SUBJECT: RESOLUTION AUTHORIZING EXECUTION OF THE SECOND AMENDMENT TO THE SITE LEASE AGREEMENT BETWEEN FORSYTH COUNTY AND THE CITY OF WINSTON-SALEM, AS JOINT LANDLORDS, AND NEW CINGULAR WIRELESS PCS, LLC, AS TENANT, FOR THE INSTALLATION OF ANTENNAS, ASSOCIATED CABLES, AND ADDITIONAL TELECOMMUNICATIONS EQUIPMENT (GENERAL SERVICES DEPARTMENT)

SECOND AMENDMENT TO AGREEMENT CE140329

CITY OF WINSTON SALEM TOWER

FINAL ANTENNA LAYOUT

C-3

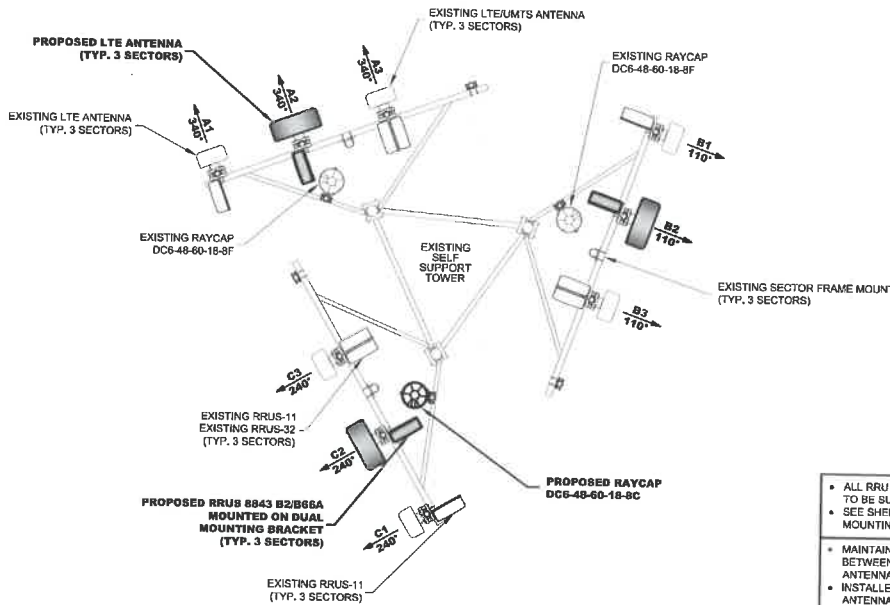
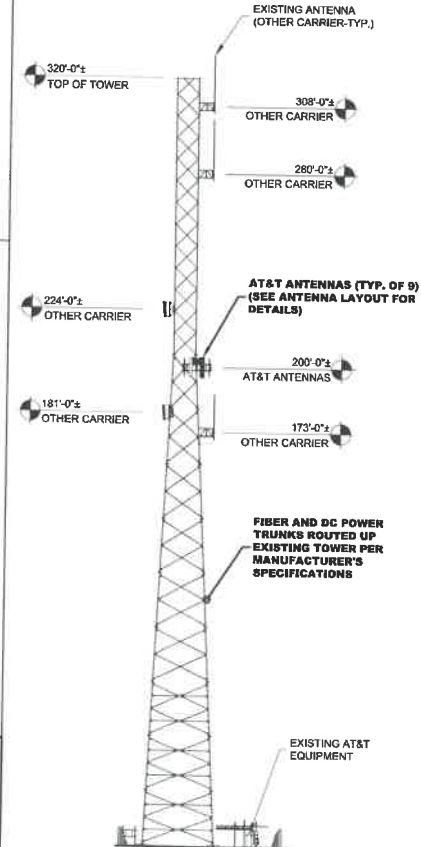
- REMOVE (3) HBXX-6516DS-VTM ANTENNAS
- REMOVE (3) RRU5-12-A2
- ADD (3) NNH4-65C-R6 ANTENNAS
- ADD (3) RRU5 8843 B2/B66A
- ADD (1) DC6-48-60-18-8C
- RRU MOUNTING BRACKETS NEED TO INCLUDE (6) NEW B2B DUAL RRU MOUNTING BRACKETS - SUPPLIED BY AT&T
- SWAP OUT LTE DC DC TRUNK FOR A 6AWG TRUNK
- ADD (2) #6AWG DC POWER TRUNKS
- ADD (1) ALARM CABLE
